SUBJECT: Forwards FSAR changes which address SER Confirmatory Item 25.
 re: LPCII & LPCS valve interlocks. One P&ID drawing also encl.

October 30, 1985
(NMP2L 0523)

Re: Nine Mile Point Unit 2
Docket No. 50-410

Enclosed are changes to the Final Safety Analysis Report which address Safety Evaluation Report Confirmatory Item Number 25, Low Pressure Coolant Injection and Lower Pressure Core Spray valve interlocks. Also attached are Piping & Instrumentation Diagrams of the Low Pressure Coolant Injection and Low Pressure Core Spray which will be incorporated into the Final Safety Analysis Report. These changes will be included in FSAR Amendment 23.

5.4-13
14F2

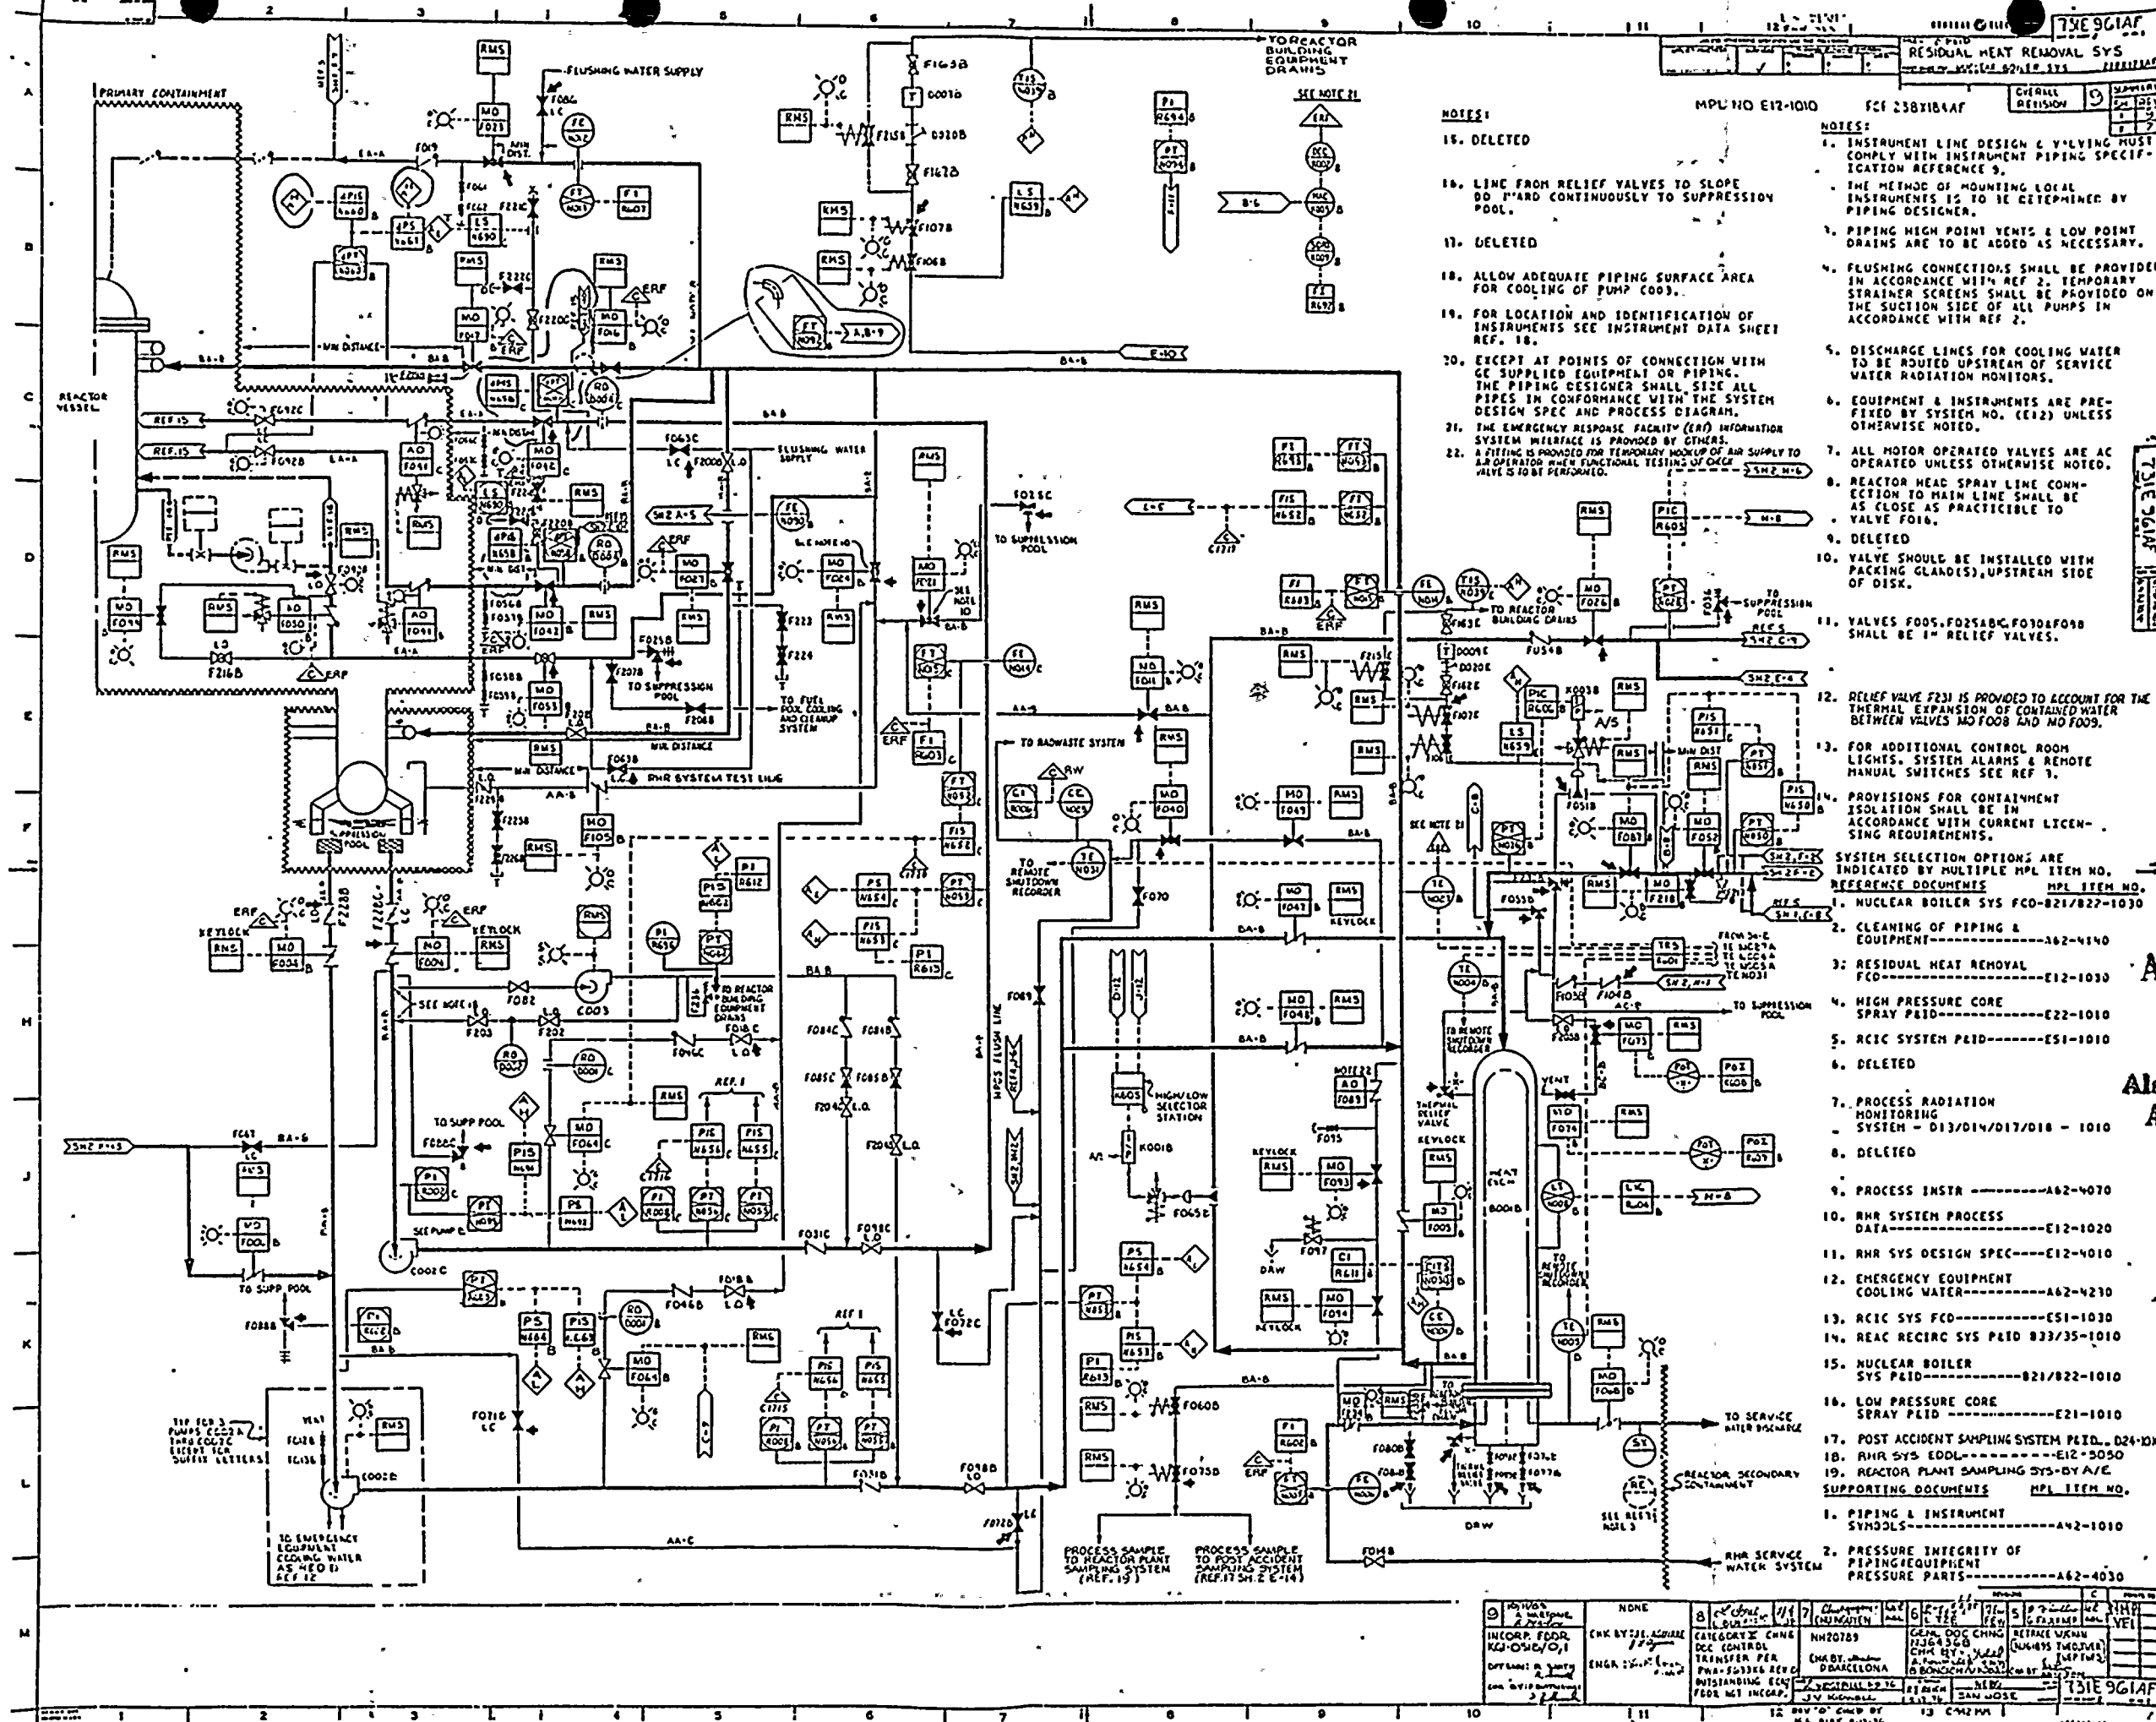
Schematic arrangements of system mechanical equipment are shown on Figure 5.4-13. LPCI component control logic is shown on Figure 7.3-6. Instrument specifications are listed in Table 7.3-4 and Chapter 16. Elementary diagrams are identified in Section 1.7. Operator information displays are shown on Figures 5.4-13 and 7.3-6.

The LPCI system is initiated automatically by reactor vessel low water level and/or by high drywell pressure. The system is designed to operate automatically for at least 10 min without any action required by the control room operator. Once initiated the LPCI logic seals in and can be reset by the control room operator when initial conditions return to normal. Refer to Figures 5.4-13 and 7.3-6 for a schematic representation of the LPCI A and the LPCI B/C initiation logic, respectively.

3. Differential pressure transmitters monitor the pressure difference between the low pressure side of each LPCI injection valve MO FO42A (MOV24A), FO42B (MOV24B), FO42C (MOV24C) and reactor pressure. When the differential is low enough and power is available at the associated pump motor bus, the injection valve is signaled to open.

Because LPCI injection valves E12-F042A, B, and C are part of the emergency core coolant system (ECCS), only a LOCA signal and low differential pressure permissive signal are provided to open valves F042 as is required. Testable check valves E12-F041A, B, and C are downstream of valves F042.
